Technical Publication SJ2015-1

**MINIMUM LEVELS REEVALUATION: LAKE MELROSE  
PUTNAM COUNTY, FLORIDA**

Jane W. Mace

St. Johns River Water Management District  
Palatka, Florida

Figure 9. Wetland vegetation map for Lake Melrose

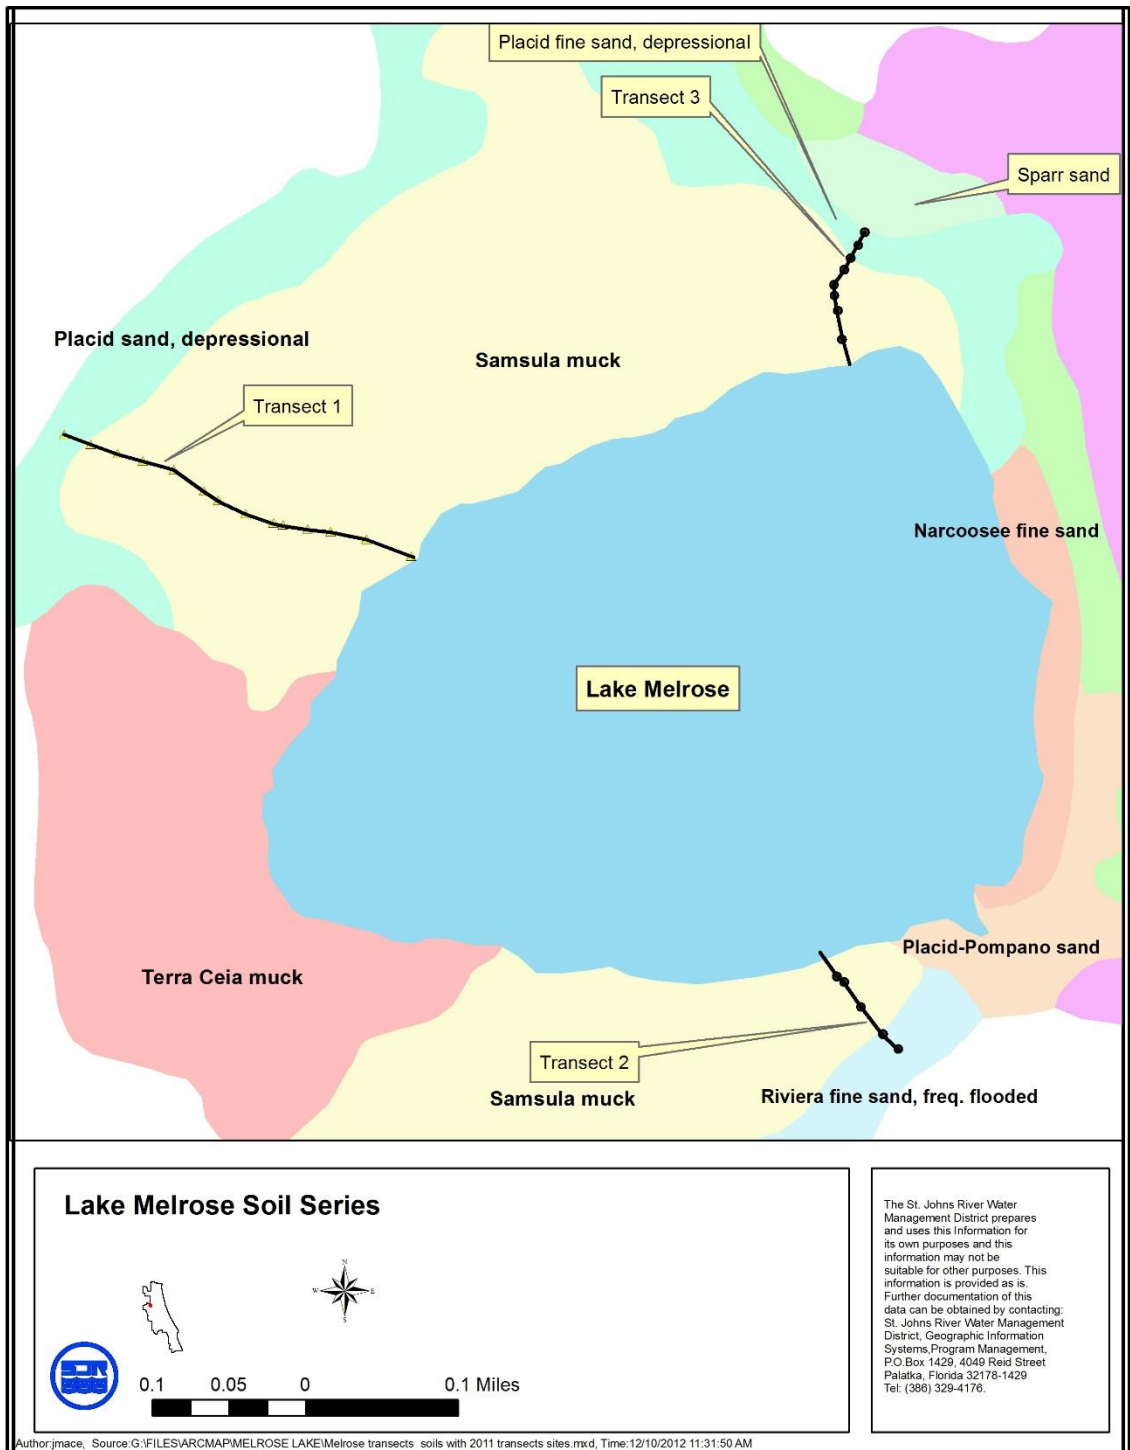
<b>Peer Review Comments – November 14 and 16, 2012; January 17, 18, and 23, 2013</b>		
<b>Reviewer</b>	<b>Text Reference</b>	<b>Peer Review Comments and resolution</b>
Wilson	Specific comments - Nov 14, 2012	8.) Figure 9. Floating marsh is an important component of each transection, and a symbol for it is in the legend of this map, but there is no floating marsh shown on the map. <i>The wetland map is great but not perfect thus delineated floating marsh as deep marsh. Also, the wetland map delineates the hardwood swamps as hydric hammock. I updated Figure 9 Also I added the comment in report ... Detailed wetland community descriptions contained herein vary from those mapped due to map scale and are presented in the Results and Discussion section.</i>
Wilson	Specific comments - Nov 14, 2012	9.) Figure 9. There appear to be symbols on each transect; these should be identified in the legend or removed. This comment applies to several other figures. <i>Corrected where needed</i>
